The Former Stag Brewery, Mortlake

Project Number: WIE18671

Document Reference: WIE18671-104-R-11-5-1-DS

From: Katherine Wood <Katherine.Wood@london.gov.uk>
Sent: 08 February 2019 17:12
To: Nora Balboni; Stuart McTaggart; Abby Crisostomo
Cc: Anna Gargan; Suzanne Robson
Subject: RE: Stag Brewery (GLA ref: 4172a/b) drainage strategy

PROPOSED SURFACE WATER DRAINAGE STRATEGY

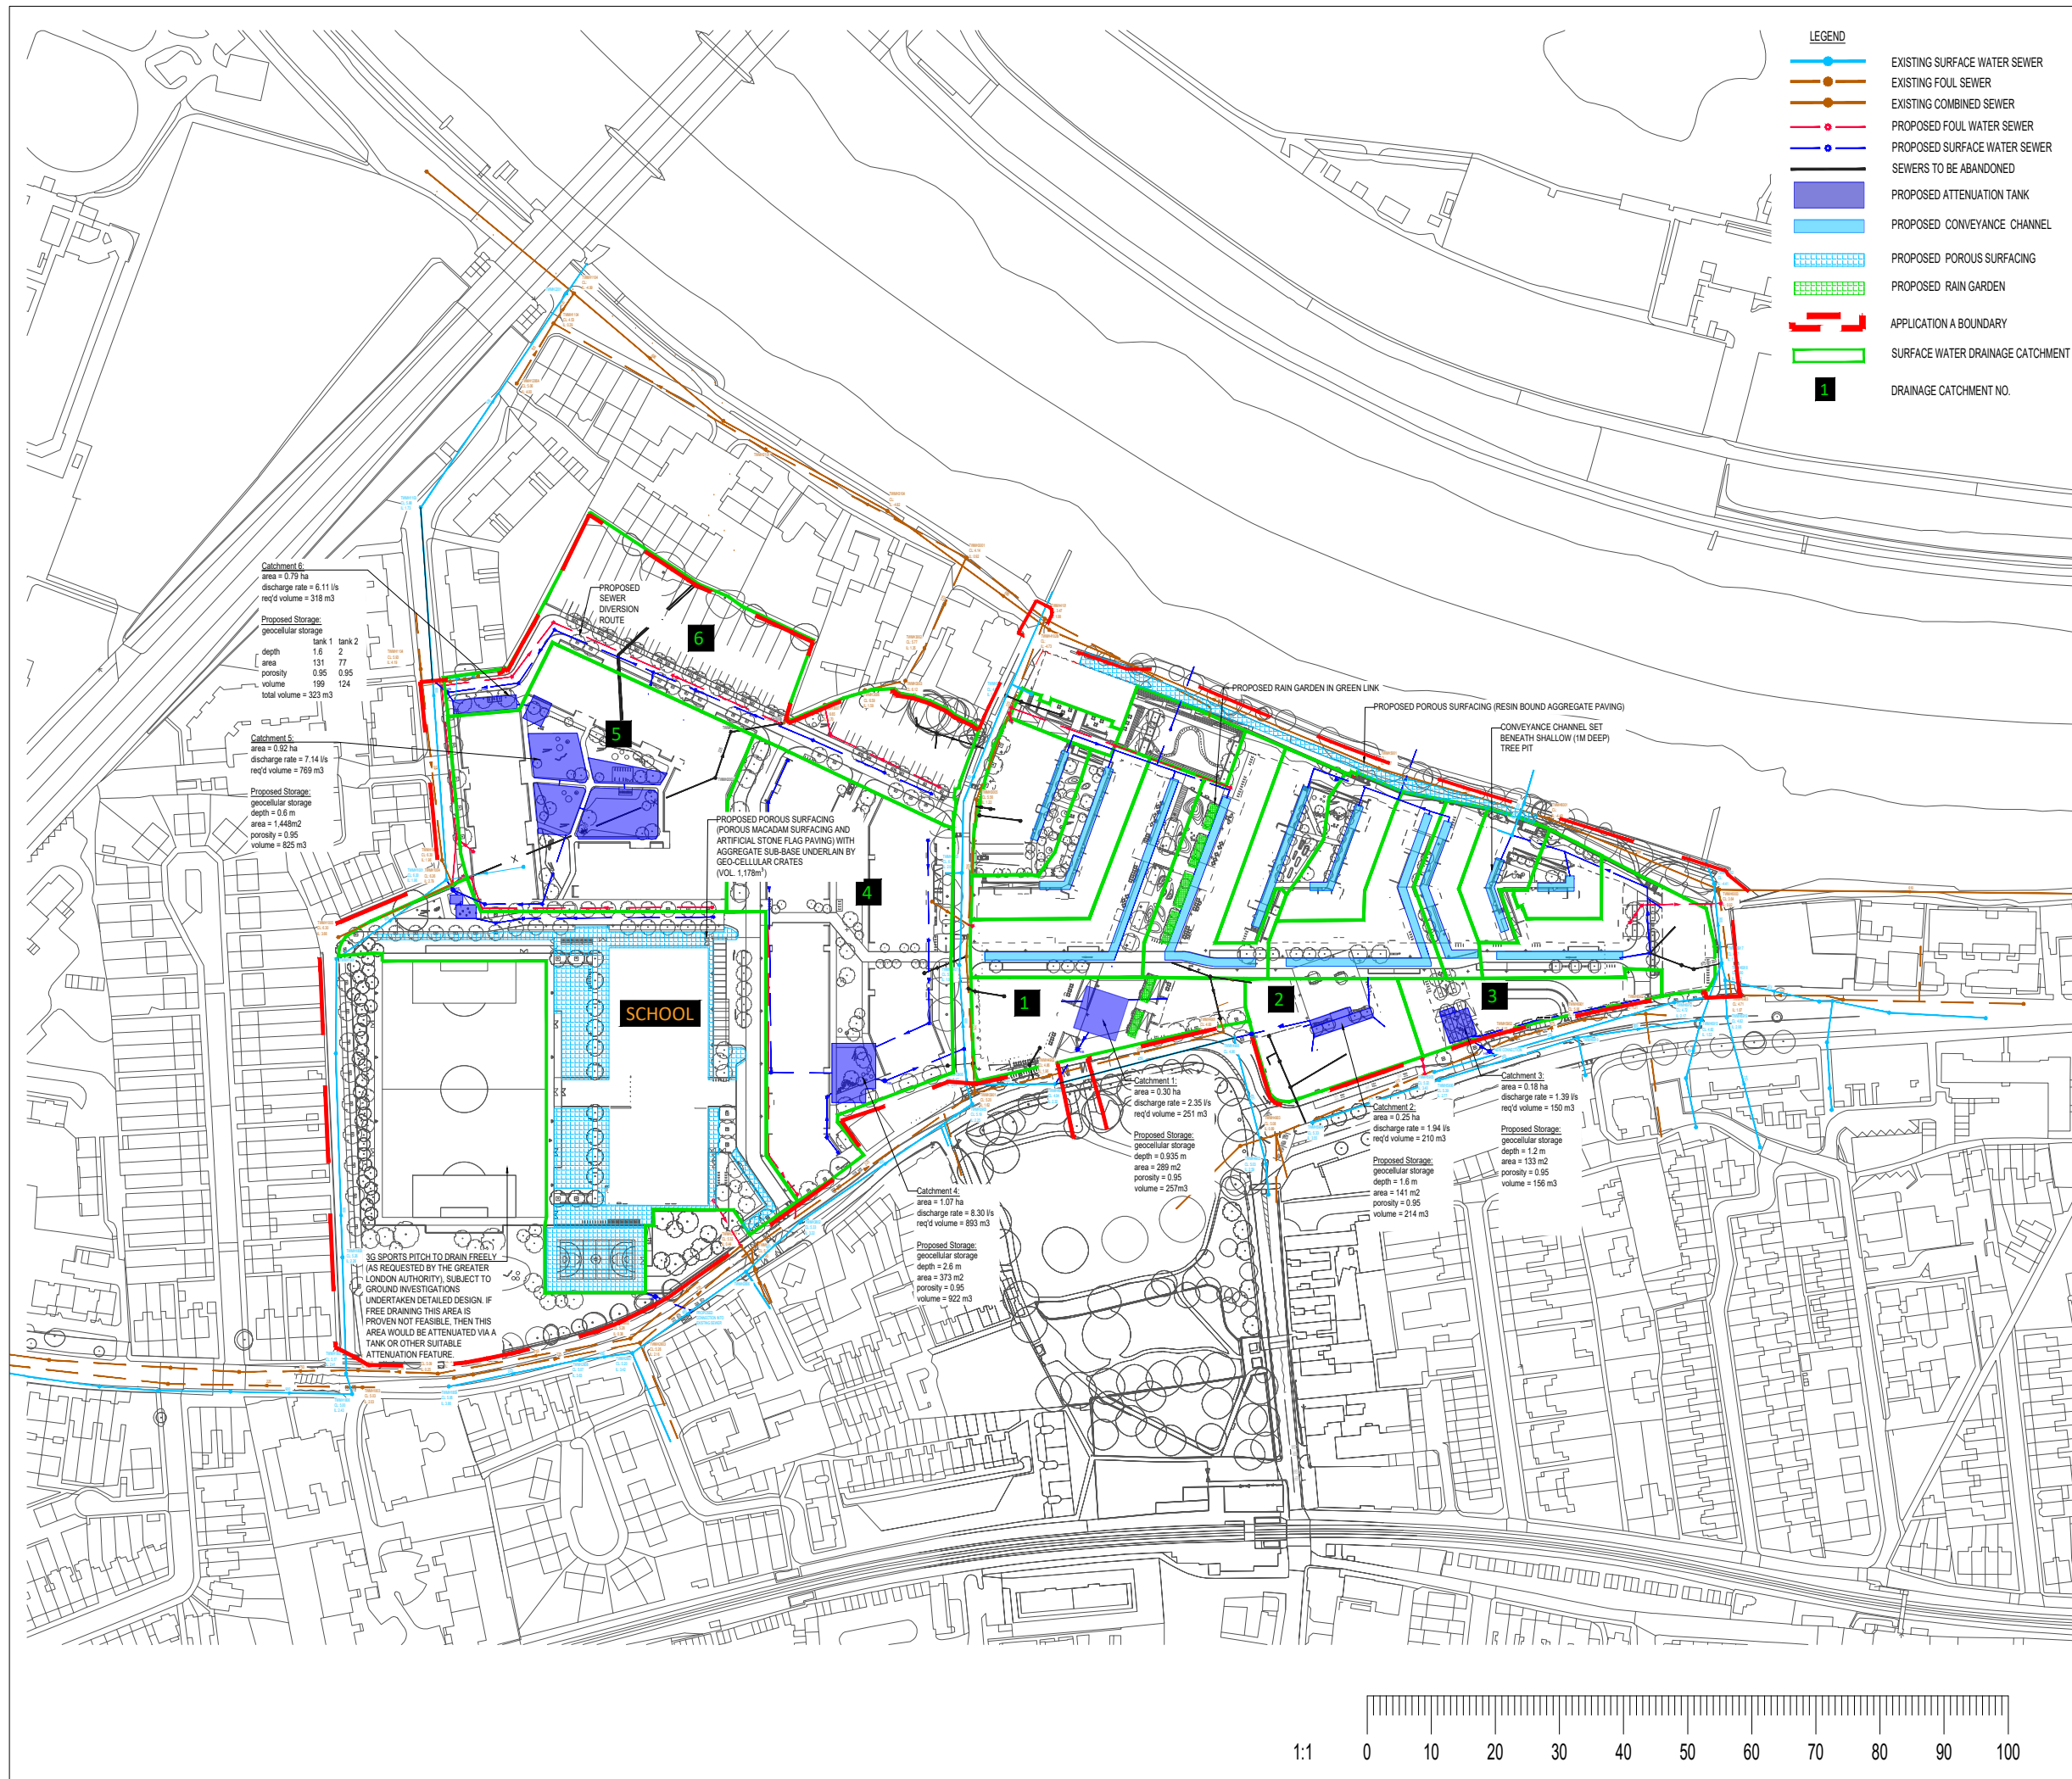
1. The intent of the original drainage strategy was to show that it is possible within site constraints to meet the absolute minimum requirements of London Plan policy 5.13.
2. We would like to see that all efforts have been made to get as close to possible to the policy targets (i.e. greenfield runoff, drainage hierarchy, and a preference for SuDS with multiple benefits). We expect that on large sites such as this the policy targets should be able to be met in most cases.
3. Waterman will produce an addendum to the drainage strategy to more clearly show how the drainage will integrate SuDS with multiple benefits and identify an approximate maximum reduction in discharge rate. Where appropriate the reduction in discharge rate can be caveated with assumptions/risks that need confirmation during detailed design (e.g. infiltration rates of the subgrade below the 3G pitch).

"I have reviewed the Applicant's second response to our Stage 1 comments. Following our previous response at the end of October the final point of contention appears to be the proposed discharge rate where the site will drain to the public sewer.

It is noted that the London Plan and DEFRA national guidance require a development to achieve as close to greenfield runoff rate as possible (approximately a >90% reduction from pre-development rates for a brownfield site). In this case the Applicant is proposing to reduce the discharge by 50%, well short of the policy requirements. The Applicant should calculate the greenfield runoff rate and provide calculations showing the attenuation storage required to meet this discharge rate. The Applicant should then seek to include additional attenuation storage to get as close to this value as possible. Our original comments suggested building the biodiverse roofs as green/blue roofs to provide additional storage and this has not been addressed to date. The Applicant should then provide a clear drawing or markup clearly showing the constraints to expanding attenuation storage if discharge at greenfield runoff rate is not proposed.

- Amended drainage strategy plan to show permeable paving extents;
- Volume calculations to estimate the attenuation available within the permeable paving sub-base and rain garden feature to show that a restriction of surface water runoff beyond the minimum 50% requirement is achieved;
- Sports pitch in south-west of site removed from surface water calculations under the assumption that it would drain freely, subject to ground investigations during detailed design; and
- Summary of all SuDS included.

We understand that developments should aim to achieve greenfield runoff rates, or as close as feasible. To endeavour to achieve this we took the following approach:

1. As per the drainage hierarchy, the amount of surface water that could be discharged into the River Thames was maximised by incorporating the innovative shallow conveyance channel system;

2. For the remaining site, where discharge into the Thames was not feasible due to levels or crossing third party land, as many tanks were incorporated as possible. The horizontal constraints for the tanks include the basement extent, proposed building outlines, and landscaping. The vertical constraints include the required soil depth for tree pits and achieving a gravity connection into the surrounding sewer network. London Borough of Richmond accepted the 50% restriction during pre-application consultation. Conscious that the constraints of the site preclude a greater reduction in runoff, Thames Water were consulted to ensure that the surrounding sewer network has sufficient capacity. Thames Water confirmed capacity for both surface and foul water flows. It is important to note that the surface water flows from the development are only conveyed within the Thames Water network for maximum of 350m before discharging into the River Thames.

- Allowing the proposed sports pitch to drain freely, i.e. excluding it from the surface water calculations and therefore reducing the size requirement for the tank beneath the MUGA pitch. Subject to levels I could explore the possibility of directing surface water from other areas into this tank, reducing the restriction beyond the 50% mark. In the current strategy we assumed that the pitch would need to be positively drained due to the underlying London Clay to avoid potential water logging beneath the pitch. However, if no other areas would drain towards the pitch, allowing it to free drain could be considered.

- We took a conservative approach when designing the current drainage strategy, assuming 100% impermeable proposed area (discounting the park area in the south eastern corner of the site). We did not quantify the attenuation available within the rain garden along the green link and within the permeable paving, to demonstrate the worst-case scenario that the minimum required restriction (i.e. 50%) can be achieved within the tanks themselves. I will do a quick calculation to demonstrate the additional attenuating volume that these features would hold, reducing the restriction beyond the 50% mark.

- Exploring further areas for incorporation of permeable paving.
- The current proposals do not include for blue roofs. However, green roofs are proposed throughout the development, which, although not quantifiable, provide a betterment to the surface water runoff regime.

P02	S0	20.02.23	Corrected annotation to match storage calculations	SW	BM
P01	S0	28.07.22	ISSUED	SW	BM
Status	Date	Description		By	Chk
